### M E M O R A N D U M

**TO:** David Ploense, Rick Engineering  
**FROM:** Amber Wood Hicken, Planner I  
**DATE:** 4/22/25  
**SUBJECT:** Douglas 234 Dunkin Donuts, Site Plan  
Review Comments 04

**SITE PLAN FOR  
DUNKIN' DONUTS  
DOUGLAS 234, FILING NO. 6,  
AMENDMENT 1, LOT 4**

COVER SHEET

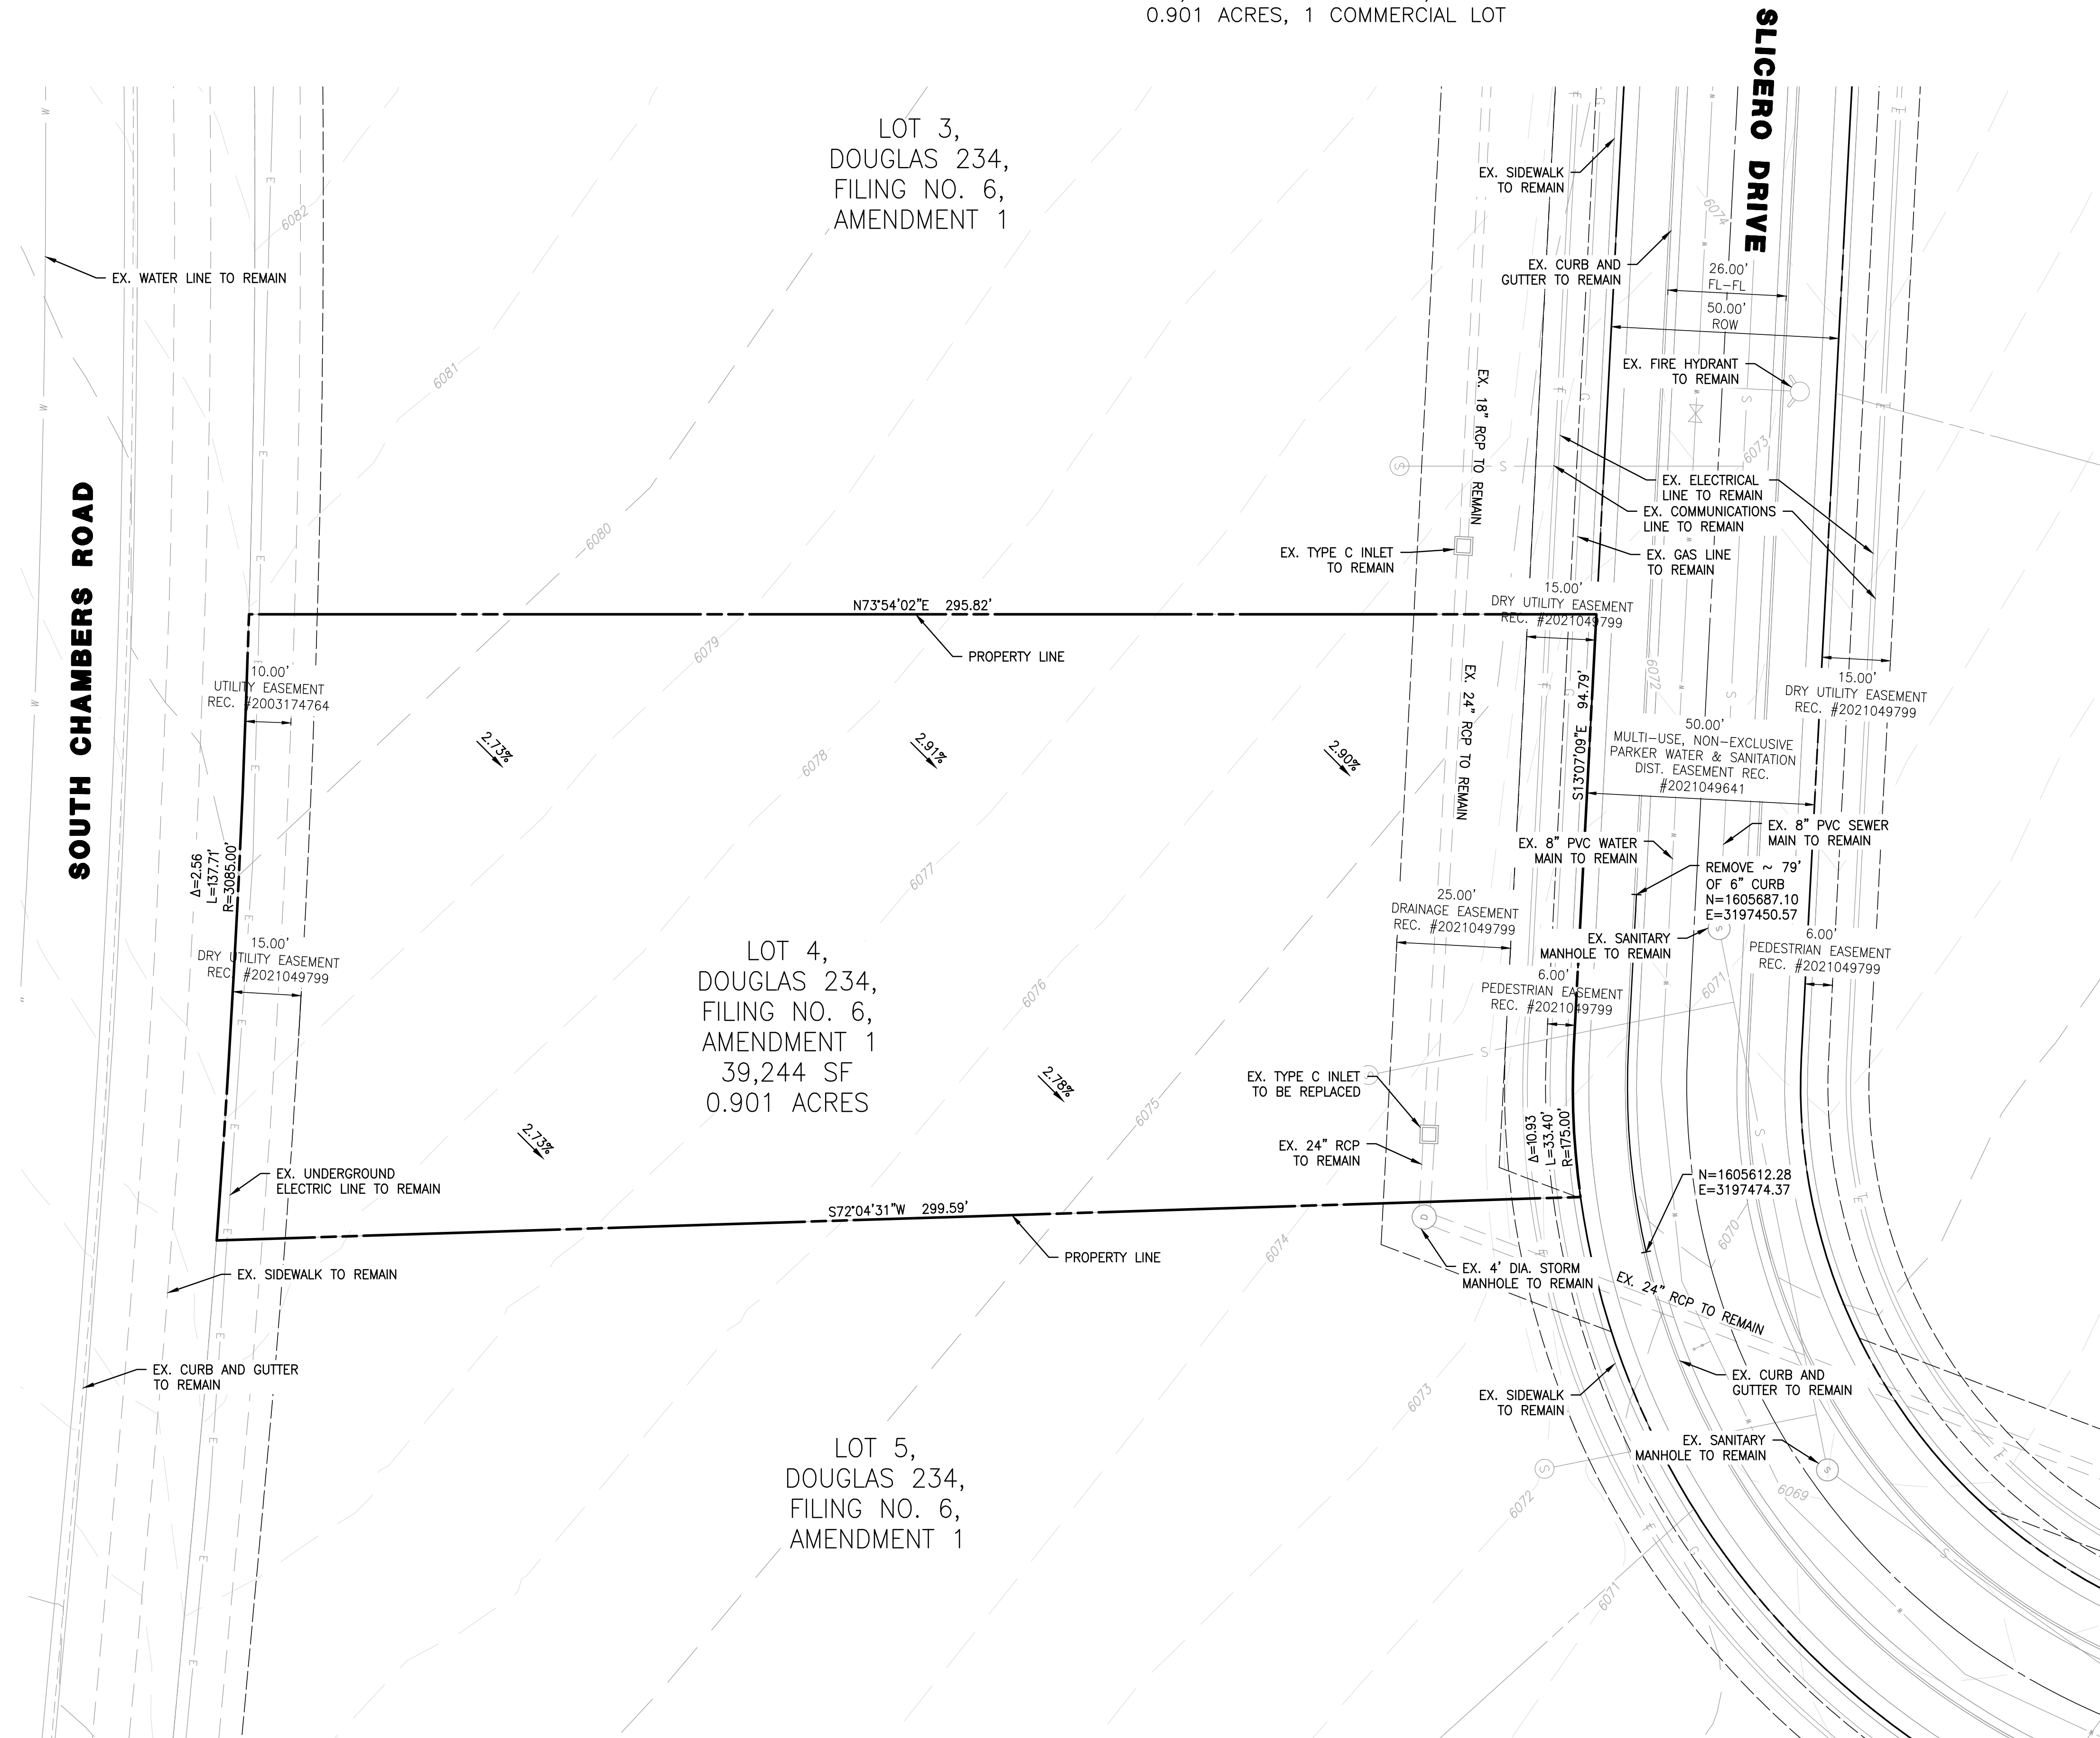
show calculation. 1 per 3 persons design capacity

Calculations have been added.
